Access Compliance Report Public Rights-of-Way (Curb Ramps)

Main Street: SIENNA_PKWY		Cross Street: S_DAISSY_ST		Location:	NW
ADA ID: RPRK211112115227	Ramp Type:Type 1 - Perpendicular	Initial Pass/Fail: Fail	Overall Compliance: No	Severity Score:	30

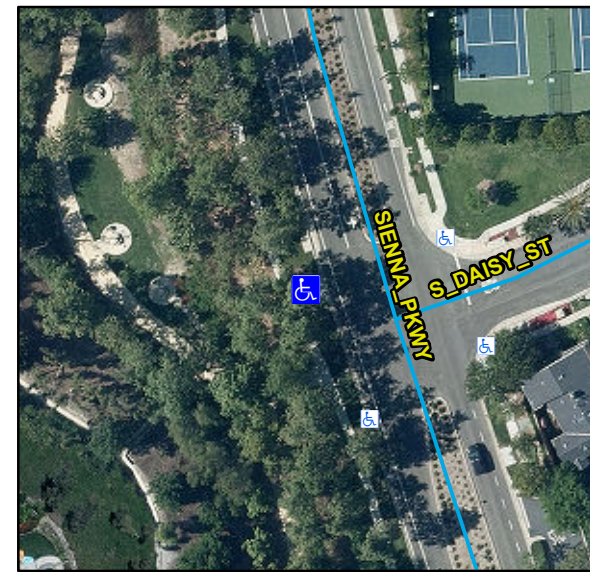
Compliance	Description	Data	Compliance	Description	Data
N/A	Ramp Length (in)	61	N/A	Flare Type LT	
Yes	Ramp Width (in)	48			N/A
No	Ramp Run Slope (%)	12.1	N/A	Flare Slope LT (%)	N/A
Yes	Ramp Cross Slope (%)	0.5	N/A	Flare Traversable LT	N/A
N/A	Landing Present	N/A	N/A	Flare Type RT	
N/A	Landing Length (in)	N/A			N/A
N/A	Landing Width (in)	N/A	N/A	Flare Slope RT (%)	N/A
N/A	Landing Run Slope (%)	N/A	N/A	Flare Traversable RT	N/A
N/A	Landing Cross Slope (%)	N/A	N/A	DWS Provided	N/A
N/A	Landing Movement Obstructed?	N/A	N/A	DWS Contrast	N/A
	Landing Movement Type	N/A	N/A	DWS Length (in)	N/A
N/A	Landing Shared	N/A	N/A	DWS Full Width	N/A
N/A	Clear Space	N/A	N/A	DWS Offset Left (in)	N/A
N/A	Clear Space To Crosswalk (in)	N/A	N/A	DWS Offset Right (in)	N/A
N/A	Marked Crosswalk 1	No	N/A	Marked Crosswalk 2	N/A
	Crossing 1 Direction	E		Crossing 2 Direction	N/A
	Marked Crosswalk 1 Width (in)	N/A		Marked Crosswalk 2 Width (in)	N/A

N/A	Ramp Inside Crosswalk 1	N/A	Yes	Ramp Inside Crosswalk 2	N/A
	Crossing 1 Slope (%)	0.4		Crossing 2 Slope (%)	N/A
	Crossing 1 Cross Slope (%)	4.4		Crossing 2 Cross Slope (%)	N/A
N/A	Gutter Ponding	N/A	No	Curb Slope	7.2
Yes	Gutter Lip Height (in)	0		Road Run Slope (%)	N/A
N/A	Gutter Run Slope (%)	N/A		Road Cross Slope (%)	N/A
N/A	Gutter Cross Slope (%)	N/A			
Yes	Overall Surface Condition: Acceptable		No	Perp Joint Present	No
	Cross Gutter Present?	No		Spandrel Present?	No
	Replace Cross Gutter?	N/A		Replace Spandrel?	N/A

Remove & Replace Entire Ramp.

R304.2.2, R204.3, STD 1115
